Application for Licence Amendment

Licence Number	L8621/2011/1
Licence Holder	Roy Hill Iron Ore Pty Ltd
ACN	123 722 038
File Number	2011/009784
Premises	Roy Hill Iron Ore Mine M46/518 and M46/519 NEWMAN WA 6753
Date of Report	03 November 2020
Decision	Revised licence granted

Figure 2: Z5IPTSF groundwater monitoring bores

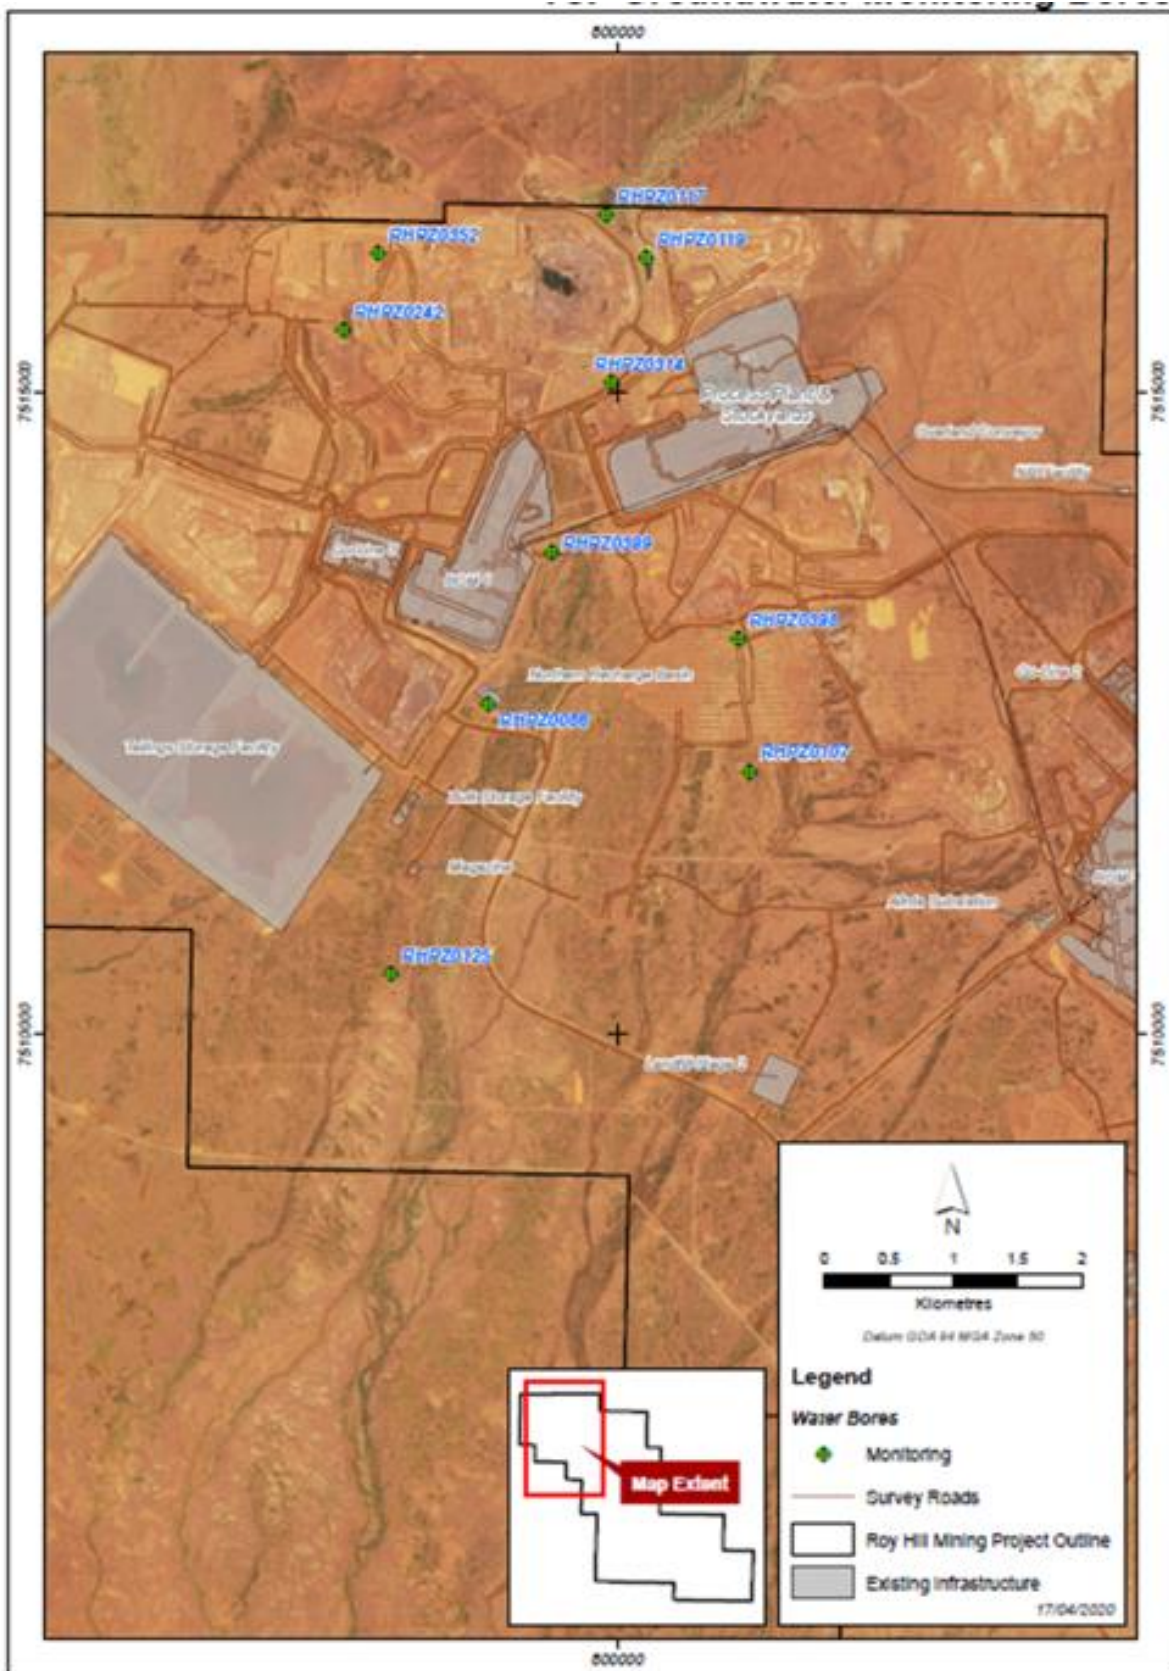
Amendment Notice 7 required installation of groundwater monitoring bores for monitoring groundwater levels at Zulu 5 In-pit Tailings Storage Facility (Z5IPTSF), to be sited under advice from an experienced hydrogeologist. Construction compliance documents for installation of ten monitoring bores were submitted on 17 April 2020 and location map as shown in Figure 2 below.

The Licence Holder has requested the removal of Z5IPTSF groundwater monitoring bores RHPZ086, RHPZ0125, RHPZ0398 and RHPZ0107 from Table 3.6.1.

GHD (2019) modelling for deposition of tailings into Z5IPTSF predicts that groundwater mounding will be small and limited to the immediate vicinity of the Z5IPTSF footprint due to the dewatering at an adjacent pit for the duration of tailings deposition.

Roy Hill's hydrogeologist has stated that Zulu and Bravo dewatering zones adjacent to Z5IPTSF form groundwater sinks.

The remaining six bores are considered adequate for monitoring groundwater levels for potential seepage and mounding at Z5IPTSF. Groundwater monitoring bores RHPZ086, RHPZ0125, RHPZ0398 and RHPZ0107 are removed from the licence.

Z5IPTSF groundwater monitoring bore construction conditions are also removed.
